THE MARYLAND-NATIONAL CAPITAL PARK AND PLANNING COMMISSION

MEMORANDUM

REVIEW TYPE: Site Plan Review
APPLYING FOR: Approval of 250 d.u.'s, including 87 TDR's and 41 MPDU's, on 62.55 net acres
PROJECT NAME: **The Meadows at Hurley Ridge (Martens II)**
CASE #: 8-03011
REVIEW BASIS: Sec. 59-D-3, M. C. Zoning Ordinance
ZONE: R-200/TDR-4
LOCATION: West Old Baltimore Road, 2000 ft. west of Frederick Road
MASTER PLAN: Clarksburg
APPLICANT: Toll Bros. Inc.
FILING DATE: October 30, 2002
HEARING DATE: May 1, 2003

PROJECT NAME: Rocky Hill Middle School Replacement

Figure 2

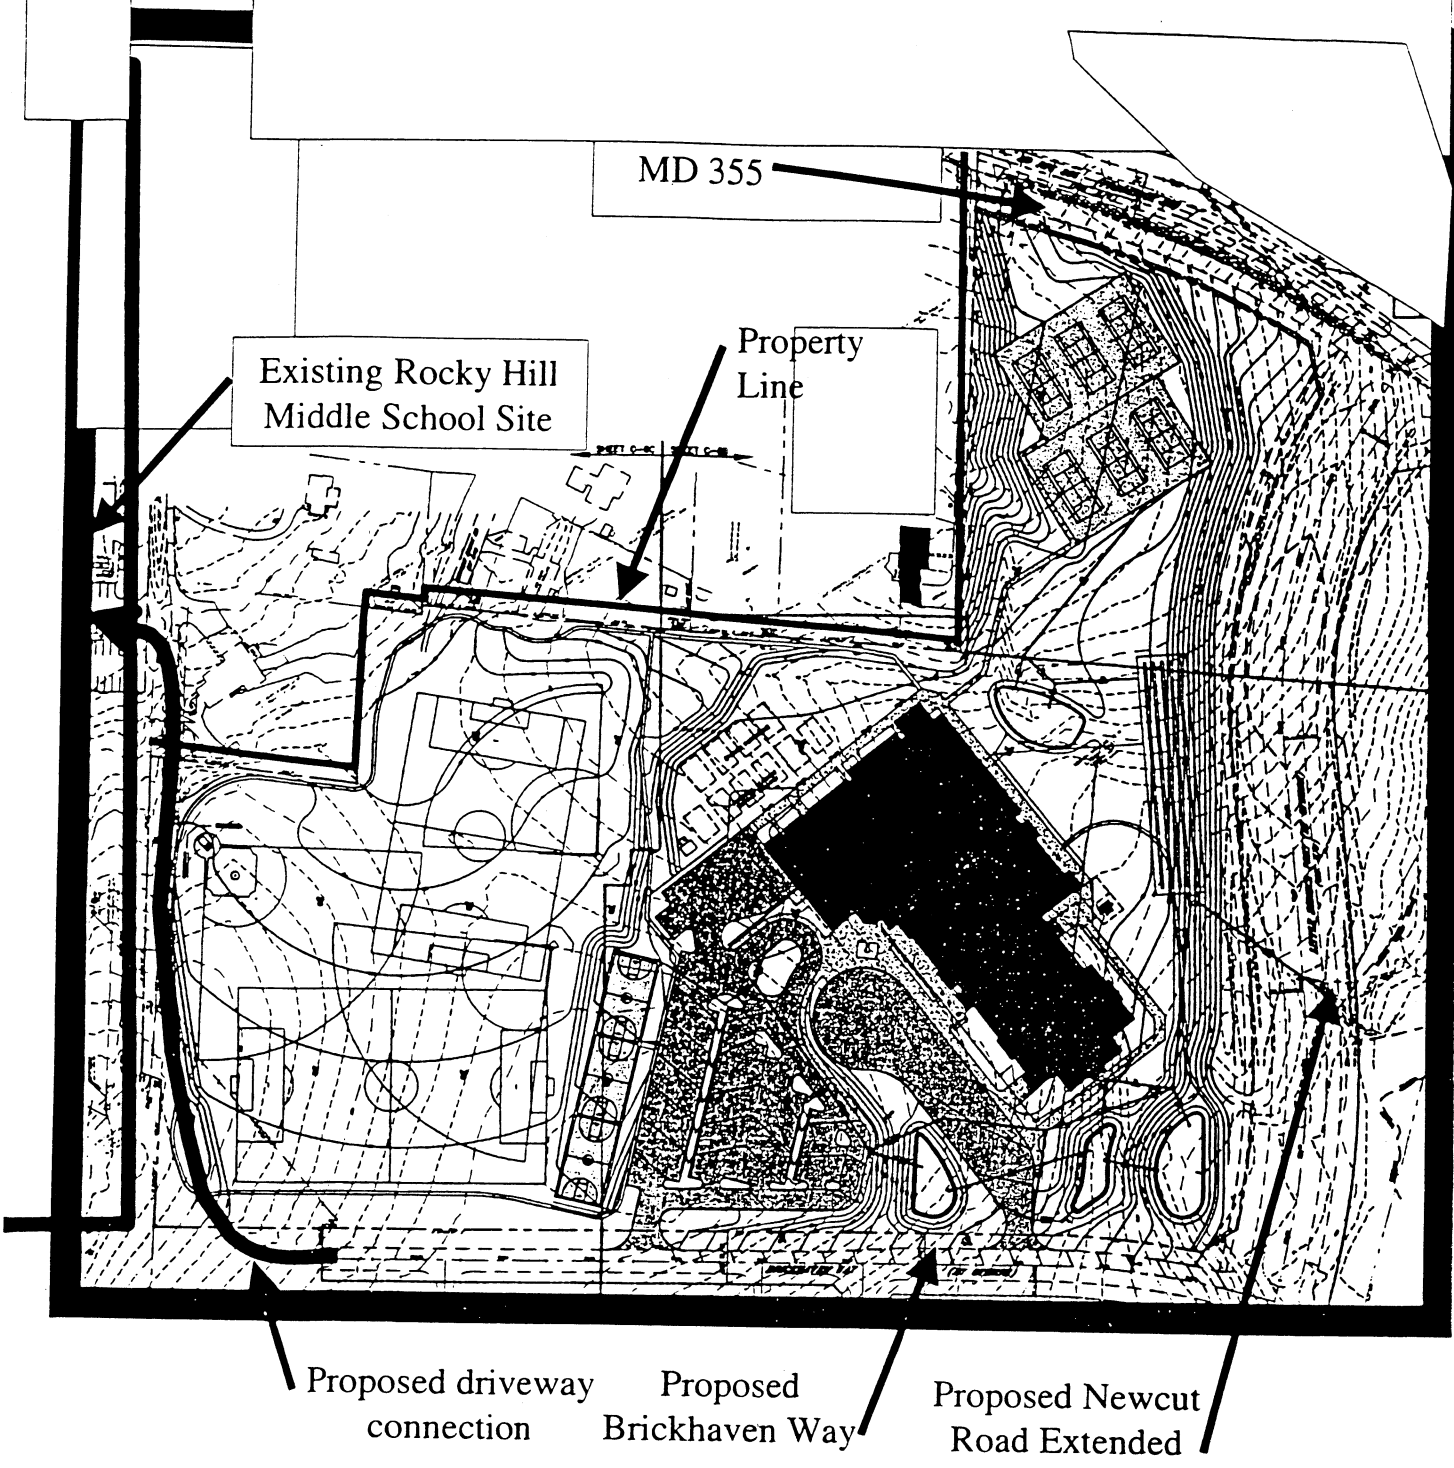
The site plan consists of the school structure, several playing fields, parking, and bus area. The building, which measures approximately 420X220 feet, would consist of three stories. It would face the intersection of Little Seneca Parkway and Brickhaven Way, at an approximately 45-degree angle from the northern property line, with the northern corner approximately 60 feet from the northern property line. This location would reduce the visual impact on adjacent residential properties.

Vehicular access and parking would be located immediately west of the building along its long side. Playing fields at the northern area consist of six (6) tennis courts, set at a minimum distance of 25 feet from the property line. Playing fields in the western section are proposed at a minimum distance of 20 feet from the property line. The existing wooded perimeter area will not be retained. Pedestrian access from adjacent streets is not shown.

Staff is concerned about the proximity of the building and fields to the adjacent homes. A detailed discussion of staff concerns and recommendations to address this issue is found in the Community Concerns Section of this report on page 6.

Staff recommends that Newcut Road Extended from MD 355 to Brickhaven Way and Brickhaven Way to the northern entrance be constructed prior to the school opening to provide needed access points to the school. The proposed temporary construction access road from the existing school site does not provide safe and adequate access to the school. The school bus loading/unloading lot is not accessible from the temporary construction access road. The internal vehicular/pedestrian circulation system as shown on the site plan is adequate.

4. Provide a continuous afforestation/tree preservation area along the northwestern property line adjacent to single family homes. This area should have a minimum width of 50 feet to include dense tree and understory planting, which ensures visual screening of all school facilities. School facilities, including paths, must not be located within this forested area.

5. Provide a privacy fence along the northeastern property line adjacent to single family homes.
6. Locate the school building to ensure a minimum setback of 80 feet from the property line to the building.

7. Provide a continuous sidewalk/bikeway along the perimeter of the site, separated from the curb by a continuous row of street trees with direct paths to the school entrance and other facilities.

8. Provide pedestrian/bike access from all sidewalks/bikeways to the school.
9. Maximize preservation of existing trees on the site.
10. Provide a lighting plan to ensure no glare or reflection into abutting or facing residential properties; lighting levels along the perimeter must not exceed a .1-foot candle.
